**Halton District School Board
RFT 25-061 School Renovation Project - Paul A Fisher PS**

Addendum No. 3

PROJECT NO. 24131
HOSSACK ARCHITECTURE

ADDENDUM NO. 3

SKA
100

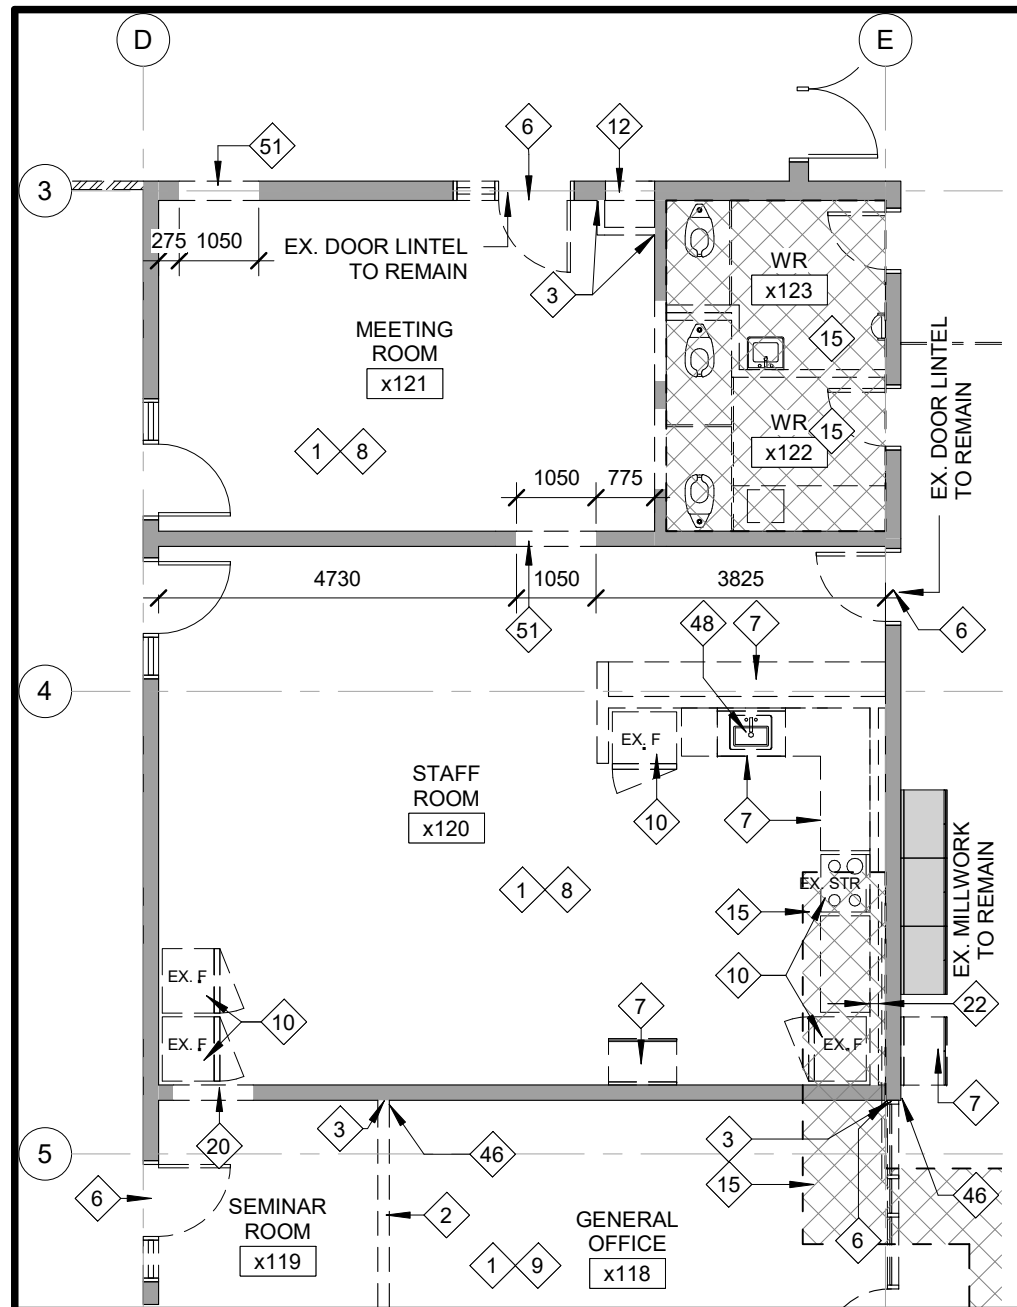
- .1 Refer to NEW Sketch AD3--100 General Office 127, Meeting Room 127A and Office 127B for layout changes to these areas.
- .2 Refer to NEW Sketch AD3-102 Calming Room 115 and Staff Lounge 120 for layout changes to these areas.
- .3 Refer to NEW Sketch AD3-103 JK-SK Classroom for layout changes to these areas
- .4 REVISE Floor Plan Note #20 to the following: ***"PATCH AND MAKE GOOD EXISTING FLOOR UPON WINDOW/DOOR REMOVAL AND REPLACEMENT. ALLOW FOR SLAB INFILL. PREPARE FLOORING FOR INSTALLATION OF NEW FINISHES AT AFFECTED AREAS. REFER TO FLOOR PATTERN PLAN. FOR JK/SK CLASSROOMS 1 AND 2 (113a AND 113b) FLOORING TO MATCH EXISTING."***
- .5 ADD Floor Plan Note #21: ***"REINSTALL REMOVED, PROTECTED AND STORED MILLWORK – TEACHERS CLOSET, LOW OPEN SHELVING AND WALL MOUNTED TACKBOARD IN PLACE. PROVIDE NEW LOW OPEN SHELVING COUNTERTOP, FINISH TO MATCH EXISTING."***

SKA
103

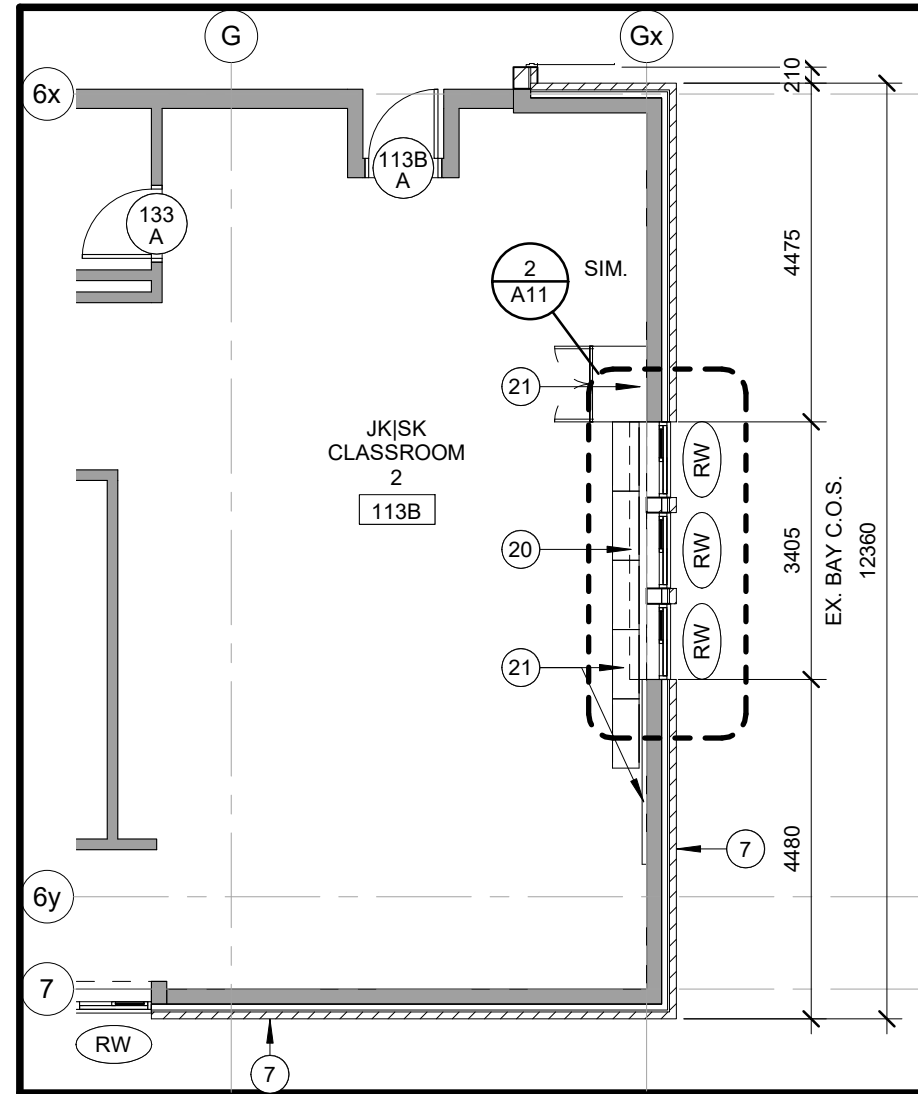
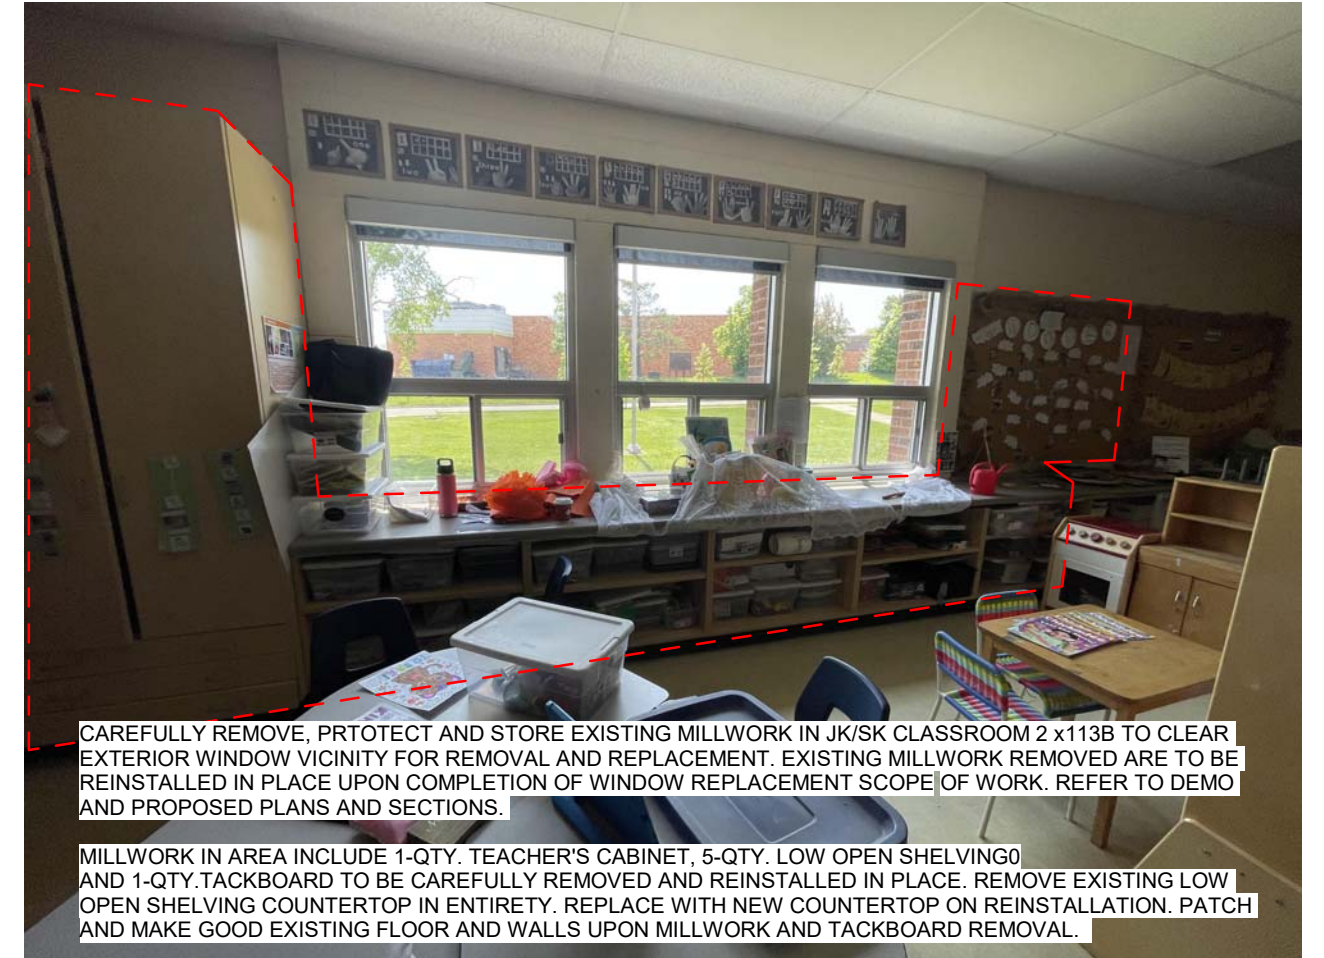
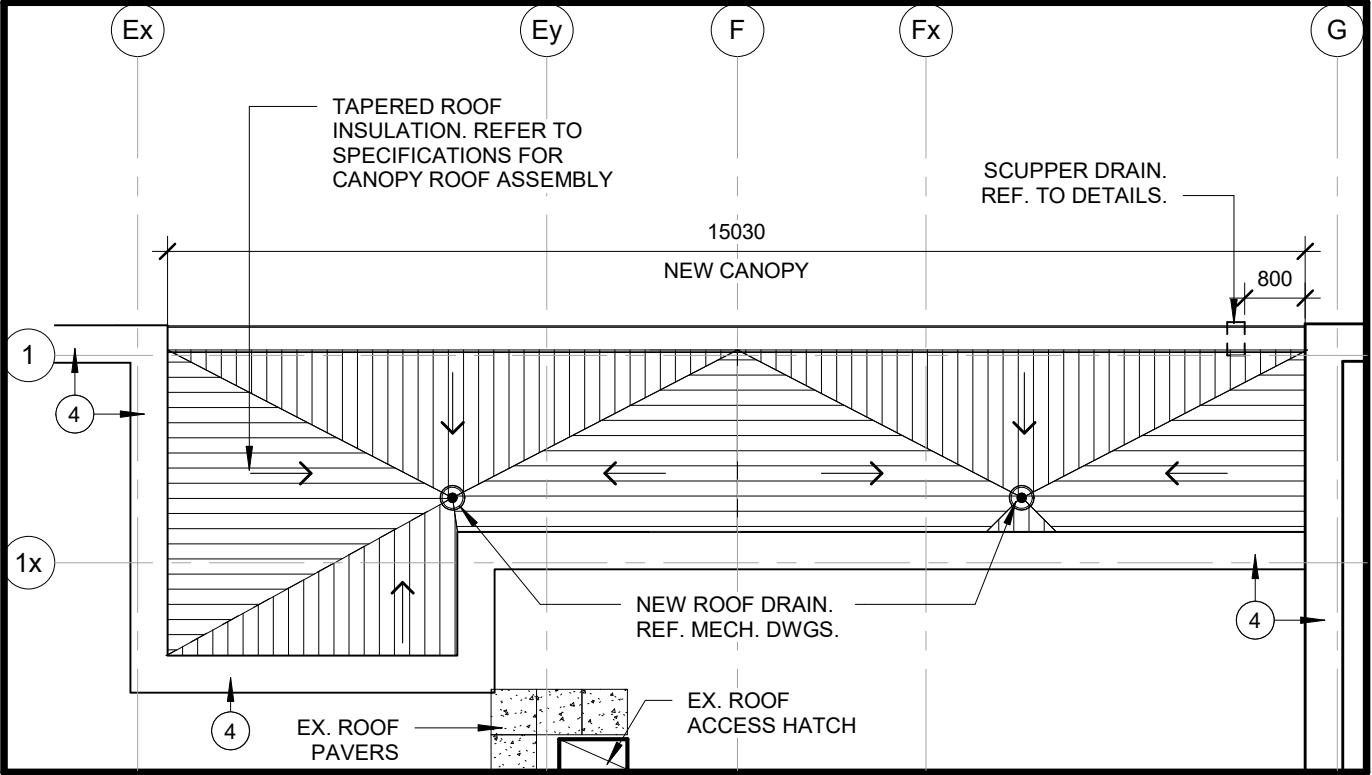
- .1 REVISE noted tags at new door openings in Meeting Room X121, Utility 103 and Mechanical Storage x105 from tag #20 to tag #51
- .2 Refer to NEW Sketch AD3-103 for demolition revisions to Millwork in JK/SK Classroom x113B

JK/SK CLASSROOM 2 - REVISION

SKA
104

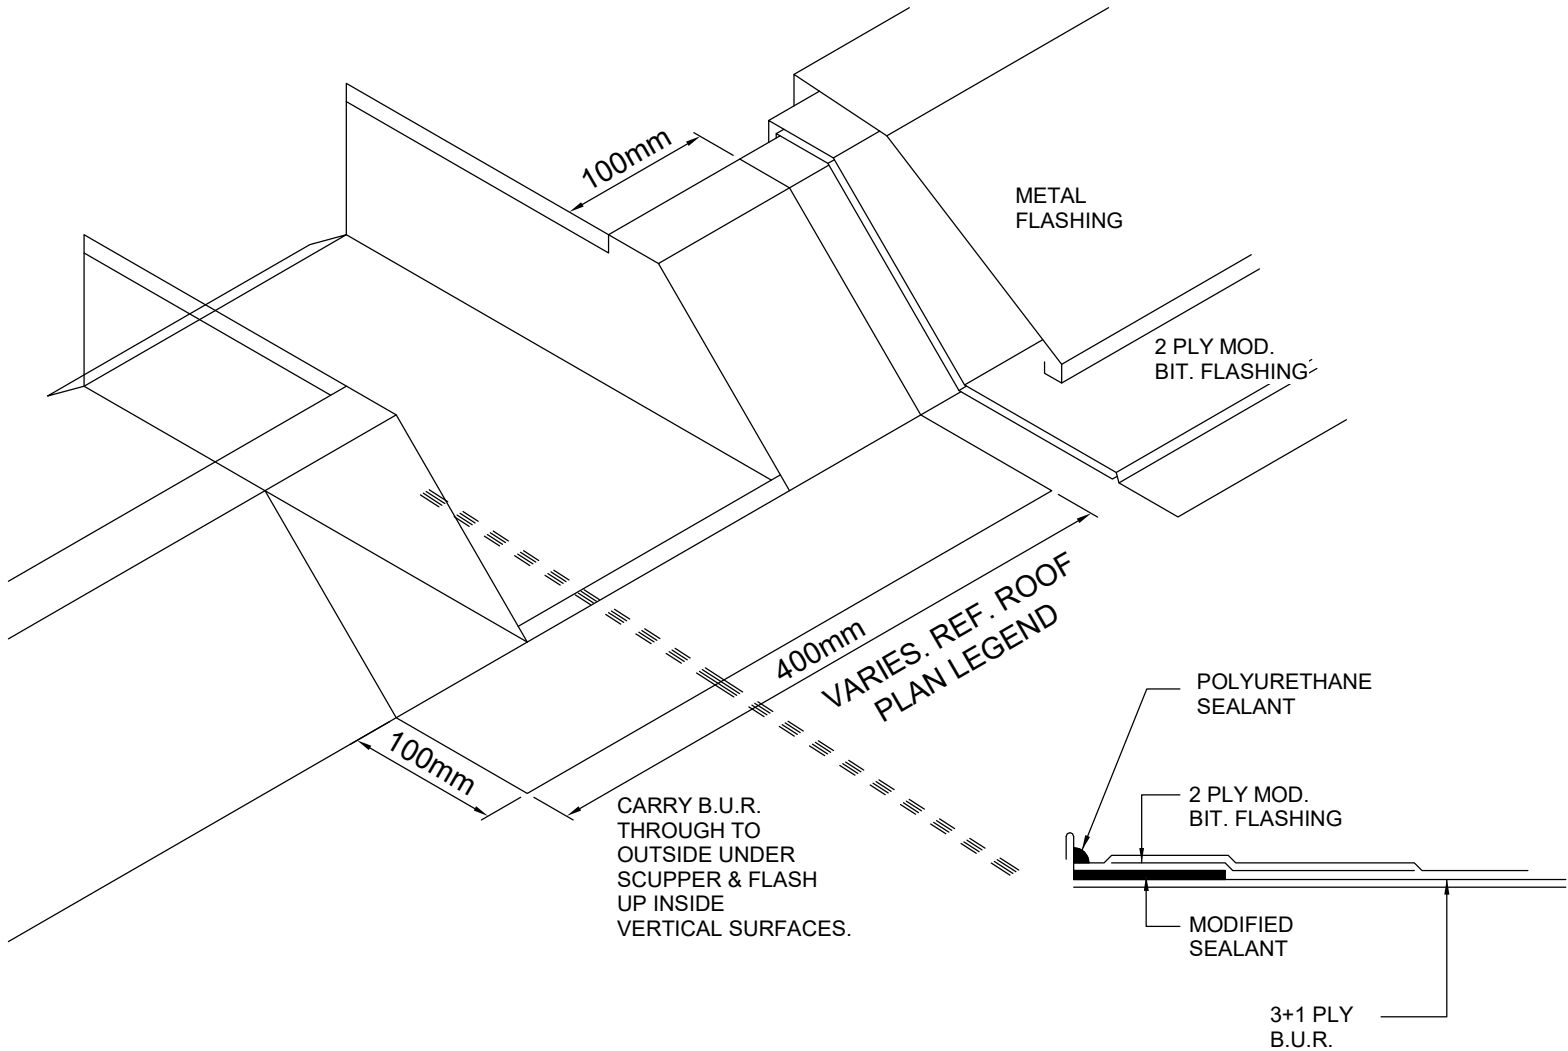
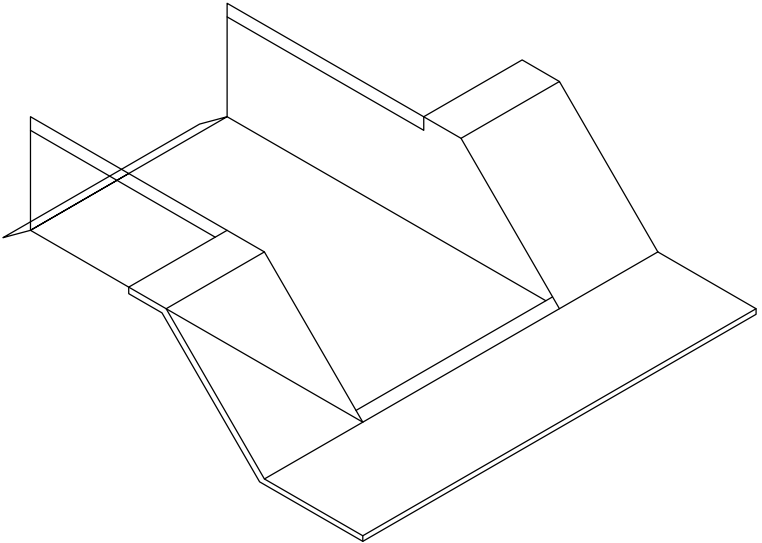
- .1 Refer to NEW Sketch AD3-104 Proposed Canopy (Roof Drain & Overflow Scupper Drain) for changes to Canopy to address Building Permit Comment.

- NOTES:
1. FABRICATE SCUPPER FROM 454gm (16oz) COPPER OR 26ga. STAINLESS STEEL.
 2. ALL SEAMS TO BE CONTINUOUSLY SOLDERED OR WELDED.
 3. EXTEND SCUPPER MIN. 200mm BEYOND OUTSIDE FACE OF EAVE.
